#### **Addendum 111 – Regulation No. 112**

#### **Revision 3 - Amendment 1**

Supplement 4 to the 01 series of amendments – Date of entry into force: 15 July 2013

**Uniform provisions concerning the approval of motor vehicle headlamps emitting an asymmetrical passing-beam or a driving-beam or both and equipped with filament lamps and/or light-emitting diode (LED) modules**

Figure 1

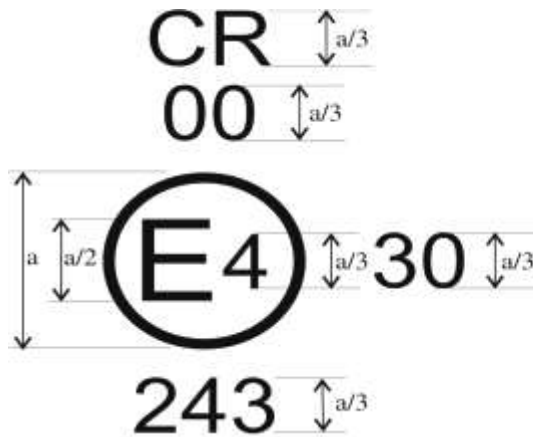
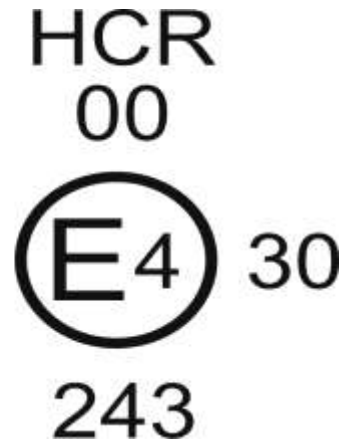
Annex 2, amend to read:

### Examples of arrangement of approval marks

$a \geq 8$  mm (on glass)

$a \geq 5$  mm (on plastic material)
